Access Compliance Report

Public Rights-of-Way

(Curb Ramps)

Intersection ID: 31368	Main Street: GREENWAY_VISTA_LN	Cross Street: LINDA_VISTA_LN	Location:	S
ADA ID: 779AFF1F9F02	Ramp Type: BlendTrans1	Initial Pass/Fail: Fail	Overall Compliance: No	Severity Score: 25
Codes/Mitigation Info/Possible Solution		Field Measurements/Component Compliance

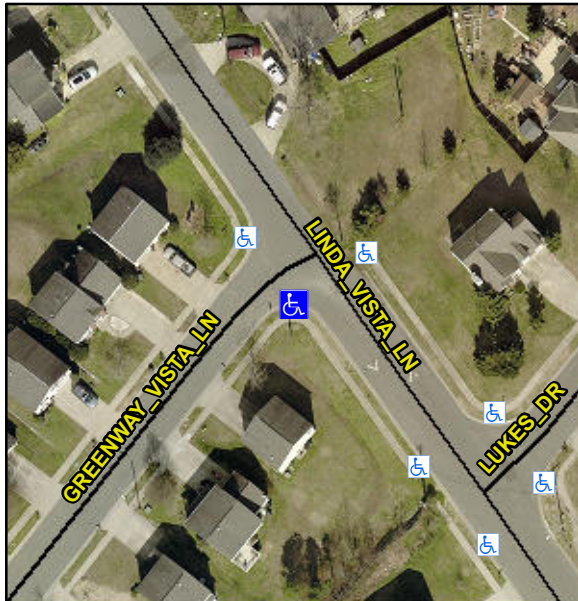
R304.5.3

Compliance	Description	Data	Compliance	Description	Data
N/A	Ramp Length (in)	44.0	Yes	BlendTrans Slope (%)	4.0
Yes	Ramp Width (in)	48.0	No	BlendTrans XSlope (%)	7.9
N/A	Flare Type LT	N/A	N/A	Flare Type RT	N/A
N/A	Flare Slope LT (%)	N/A	N/A	Flare Slope RT (%)	N/A
N/A	Flare Traversable LT?	N/A	N/A	Flare Traversable RT?	N/A
N/A	Landing Length (in)	N/A	N/A	DWS Provided?	N/A
N/A	Landing Width (in)	N/A	N/A	DWS Contrast?	N/A
N/A	Landing Slope (%)	N/A	N/A	DWS Length (in)	N/A
N/A	Landing X Slope (%)	N/A	N/A	DWS Full Width?	N/A
N/A	Landing Curb? (Y/N)	N/A	N/A	DWS Offset (in)	N/A
N/A	Shared Landing?	N/A			
N/A	Gutter Ponding?	N/A	N/A	Gutter Slope (%)	N/A
N/A	Gutter Lip Ht (in)	N/A	N/A	Gutter X Slope (%)	N/A
N/A	Painted X Walk1?	No	N/A	Painted X Walk2?	No
	X Walk 1 Direction	To NE		X Walk 2 Direction	To NW
	X Walk 1 Width (in)	N/A		X Walk 2 Width (in)	N/A
	X Walk 1 Slope (%)	3.4		X Walk 2 Slope (%)	0.4
	X Walk 1 X Slope (%)	1.7		X Walk 2 X Slope (%)	6.7

Remove & Replace Curb Ramp With Two New Directional Ramps or Equivalent.
